TOWN OF ATHERTON
 PLANNING COMMISSION APPLICATION

SITE ADDRESS: 70 Stern Lane APN 070-170-050

SUBJECT: REQUEST FOR THE REMOVAL OF THREE HERITAGE TREES AT 70 STERN LANE (APN 070-170-050)

To: The Atherton Planning Commission
From: Sally Bentz, Town Arborist
CC: Lisa Costa-Sanders- Planning Director
Date: 6/27/2016
Re: Heritage Removal Permit, 70 Stern Lane

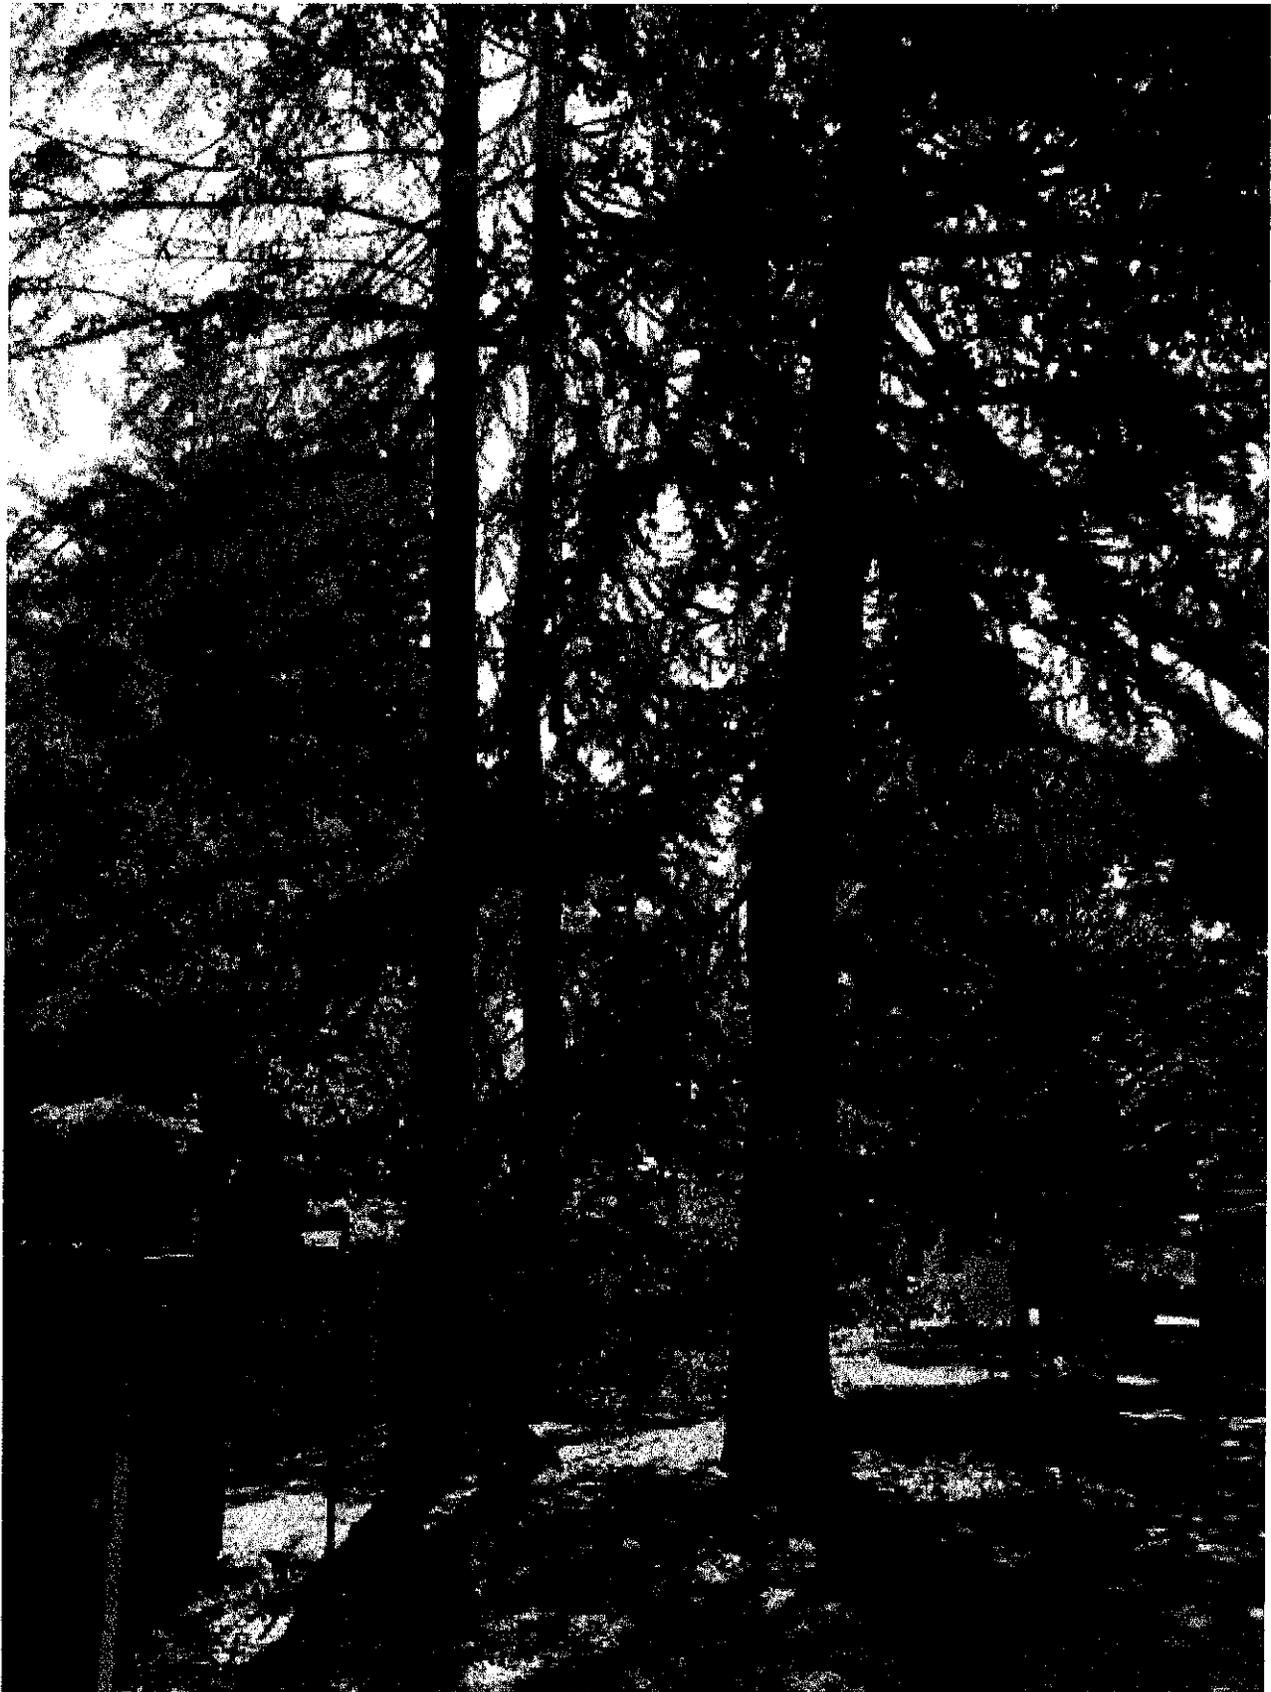
The three Cedars have been described by the Project Arborist, John McClenahan as having "a one sided crown and lack vigor" and should be removed. The cluster of three are planted too close with Tree #35 having visible "old toadstools" growing in the critical root area, Tree #36 having a "codominant leader" and Tree #37 having a "slight lean toward house". If any of the tree(s) were to fail, the house would be the target.

We are proposing to replace the three Cedars and mitigate the removals by installing thirteen mature Maidenhair Tree, *Ginkgo biloba* at both 48" and 60" box size (see attached plan). The clients are in for the long haul and the three Cedars are over mature and in decline. We would like to establish new mature trees with more vigor, which would thrive for the long term while still providing screening from the street.

The arborist report from McClenahan Consulting LLC states the trees are one sided. Toadstools were found at the base. Tree #36 was stated as having codominant leaders. Tree #37 was noted as having irregular curvature and a slight lean.

Although these are large box trees, Ginkgo's are very slow growing. The applicant would be removing mature 65' Cedars and putting in 15' Ginkgo's that are slow growing. Since the trees are very visible to the street the removal of the trees is going to have an impact on the street.

Co-dominant leaders does not necessary mean that a tree is dangerous and is not a sole reason to approve the removal of the trees. The trees are one sided because they grew together as a grove. As long as they remain a grove the trees being one sided is not an issue. Armarillia was not tested for. The lean on tree #37 is not a new lean. I do not feel the trees are dangerous.

I do not recommend that three tall mature Cedar trees that are seen from the street to be removed for new landscaping. New landscaping can be installed around the Cedar's and when the trees reach full maturity or decline new landscaping can be filled in.
